**MUNICIPAL PLANNING COMMISSION
REGULAR MEETING AGENDA**

October 23, 2024

To: Members of the Red Bank Planning Commission
From: Michael Pham, Community Development Planner
Date: October 23, 2024
Subject: Design Review for 309 Morrison Springs Road

DESIGN REVIEW STANDARDS CHECKLIST: 309 Morrison Springs Road

Site Plan

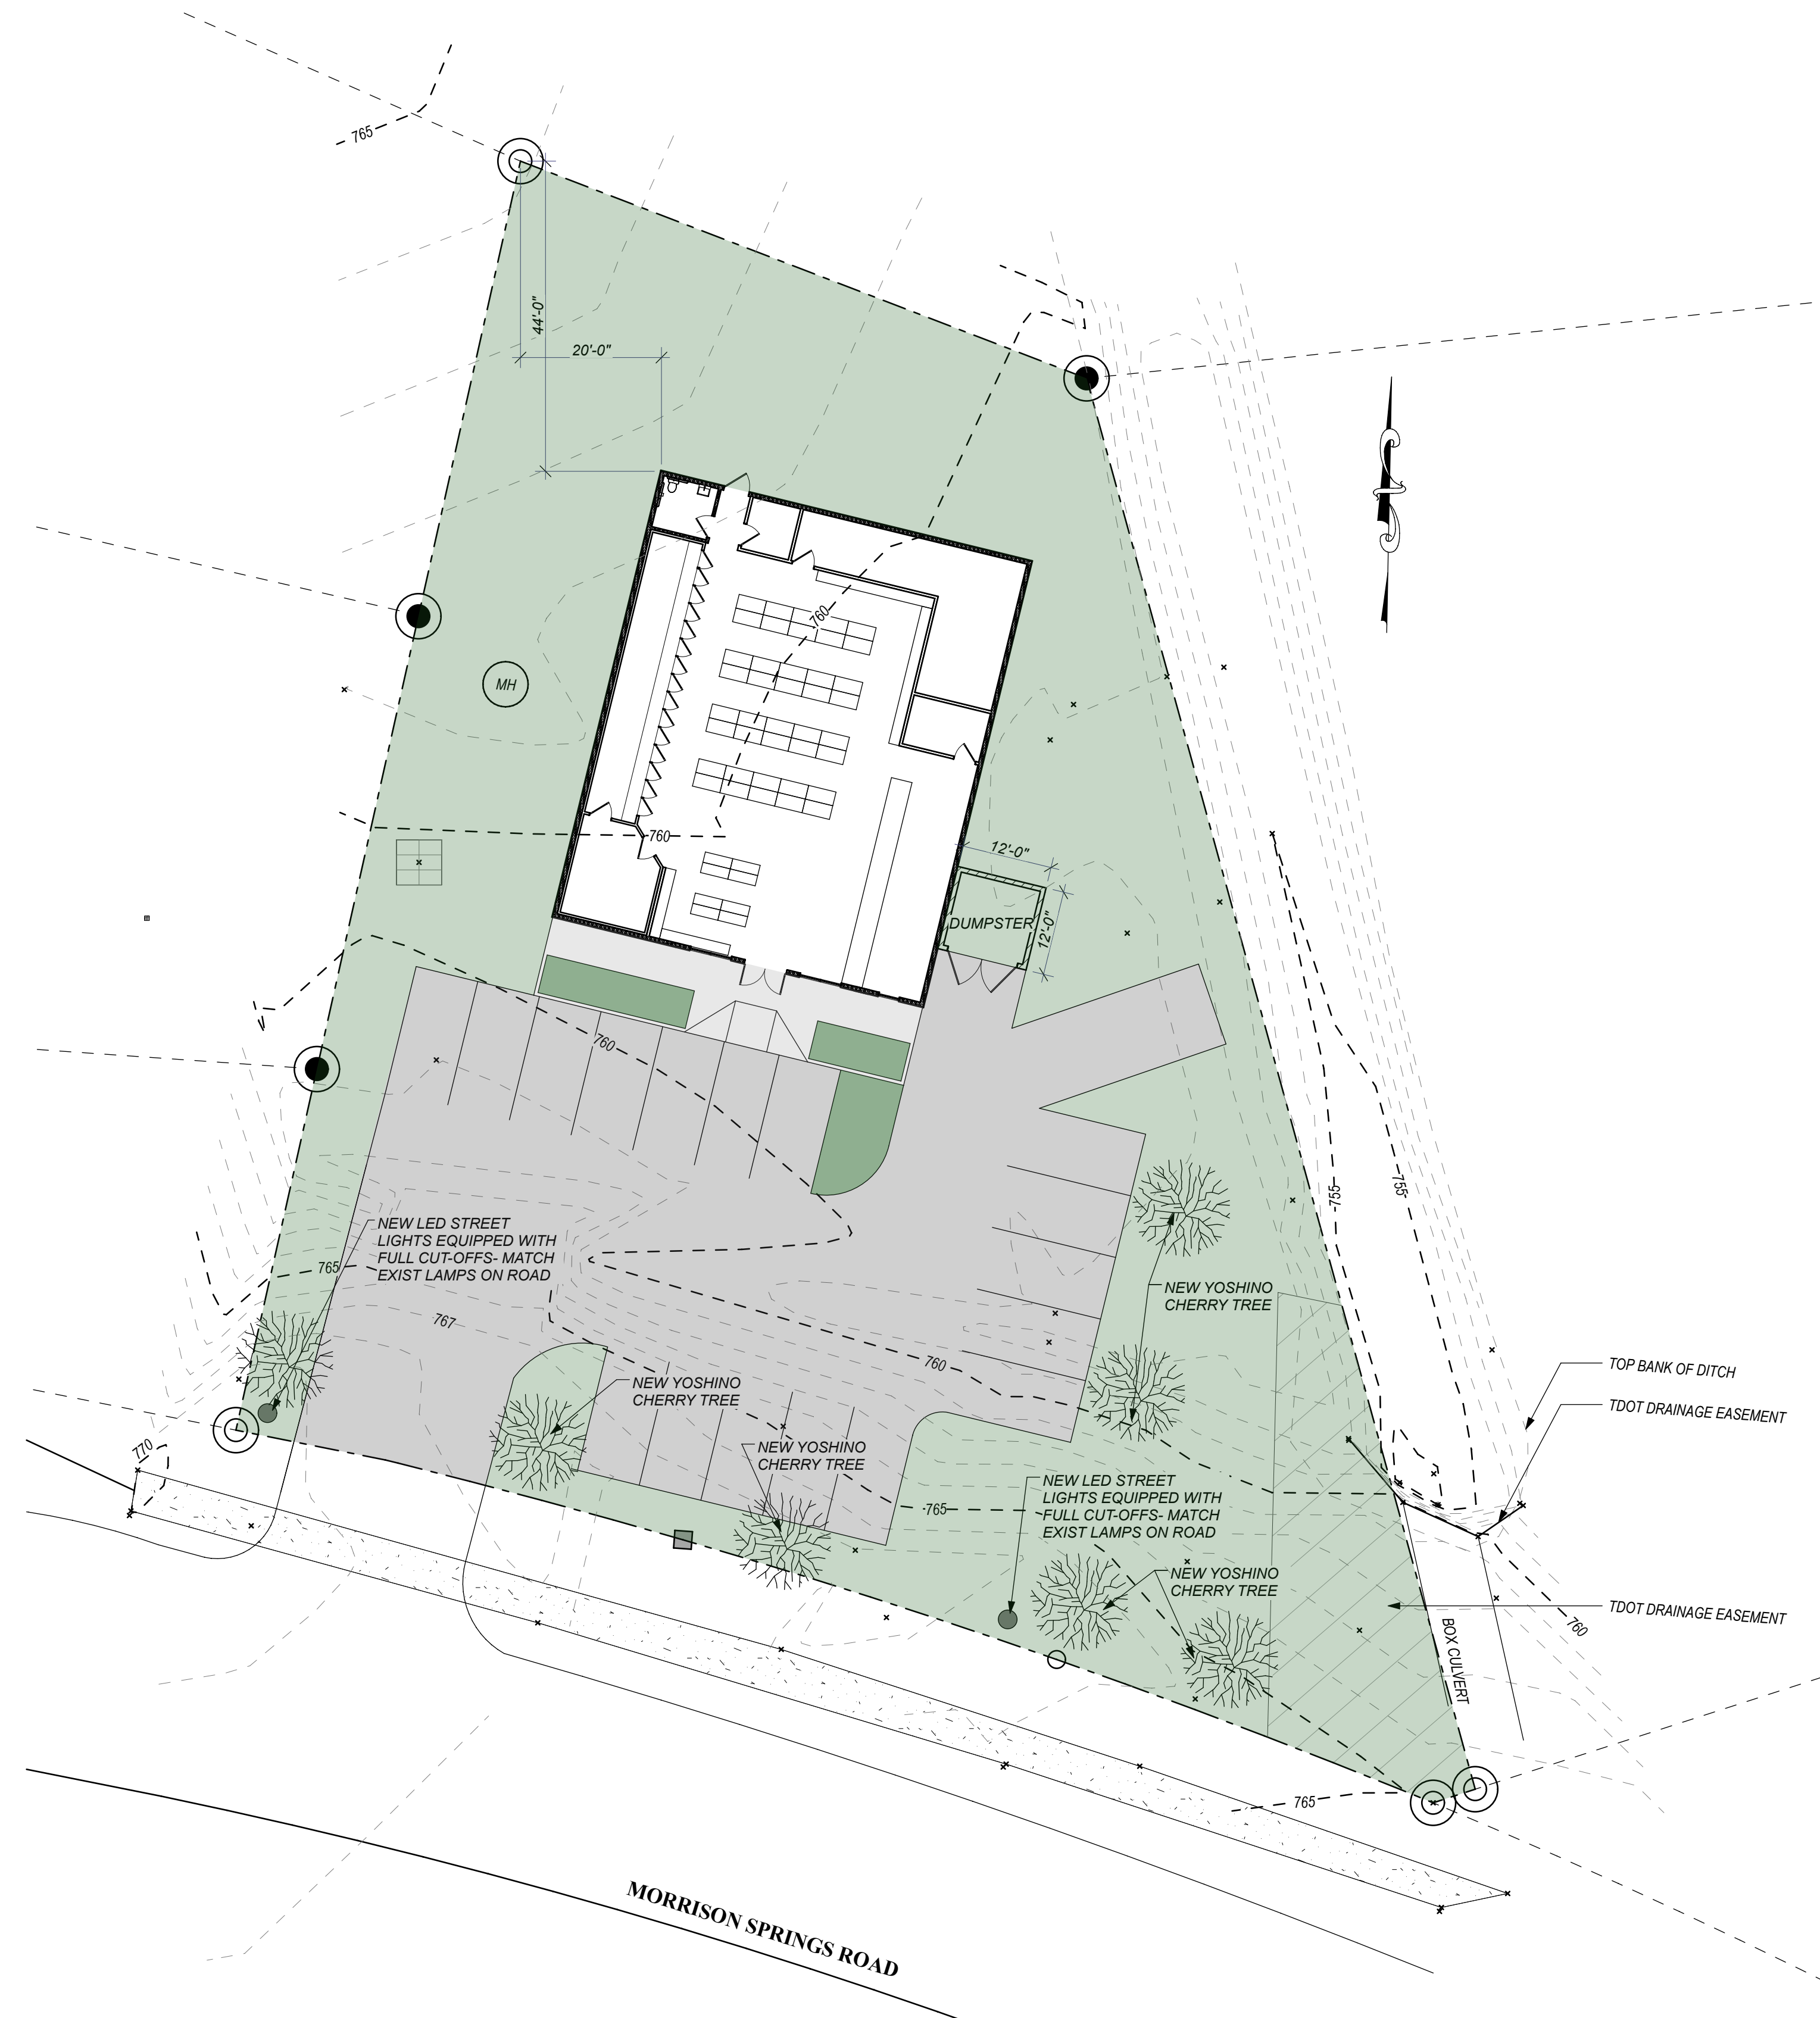
- **Setback variance** being requested for the building to be setback approximately 80' from the right-of-way; the setback requirement for the building is a minimum of 7' and a maximum of 25'; please provide exact dimension of requested building setback

- **Parking lot location variance** being requested for the parking lot to be located in front of the building; the parking lot location requirement is to the rear of any building

o Variance being requested due to existing WWTa infrastructure that incurs a physical challenge on the construction of a building with the required setback; the design review standards provide for deviations provided approval from the planning commission or city manager.

o Variance being requested due to existing WWTa infrastructure that incurs a physical challenge on the construction of a building toward the front of the lot and forcing the parking lot to the rear of the building

Exterior Elevations

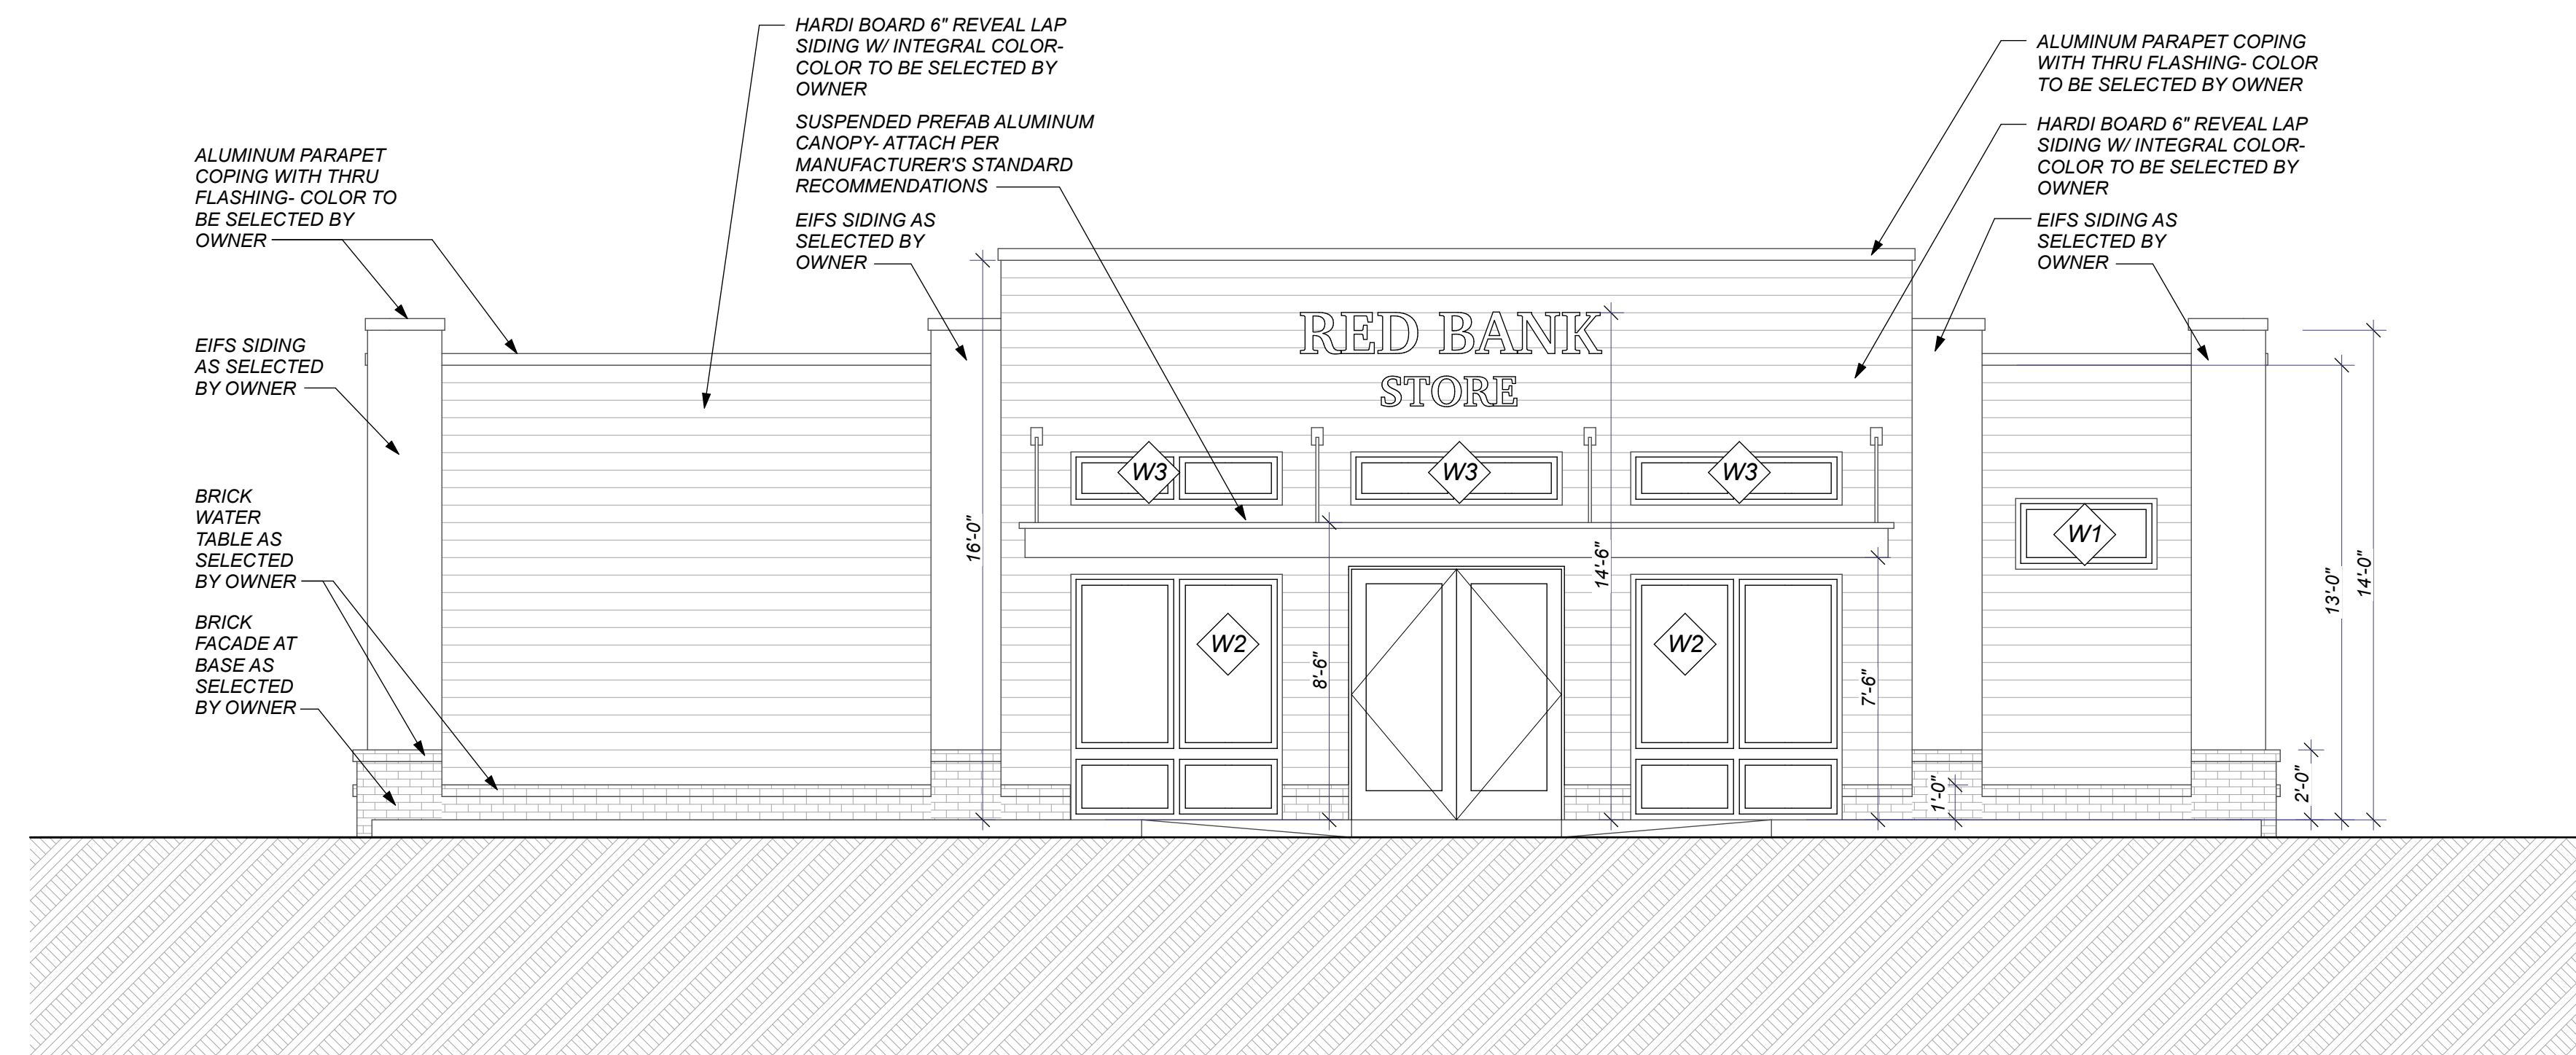
- **Façade Transparency variance** being requested; transparency requirement for retail buildings is at least 30% of the façade area comprised of clear vision glass at the ground level

Element	Exceptions and Notes	Design Standard	Description	Y/N
Façade Transparency	Specific alternative designs may be approved by the Planning Commission or City Manager. Tinted or reflecting glass is discouraged.	Retail Buildings: façades facing the public right-of-way shall have at least thirty percent (30%) of the façade area comprised of clear vision glass at the ground level	Façade has less than 30% of the area comprised of clear vision glass	Var.
		Non-Retail Building: façades facing the public right-of-way shall have at least twenty percent (20%) of the façade area comprised of clear vision glass	N/A	N/A
Massing	Articulation not required for facades less than 30 feet or not visible from the right-of-way. Horizontal articulations in buildings, such as building step-backs or rooftop balconies, are encouraged.	Façades longer than thirty (30) feet and visible from public right-of-way shall be broken down into smaller units through the use of articulation. Articulation may include: a. offsets, b. recesses, c. staggered walls, d. stepped walls, e. pitched or stepped rooflines, f. overhangs, or g. other elements of the building's mass.	Sheet A-2.1 shows one overhang and no other articulations	PC discretion

o Variance being requested due to security concerns of having significant percentage of glass façade
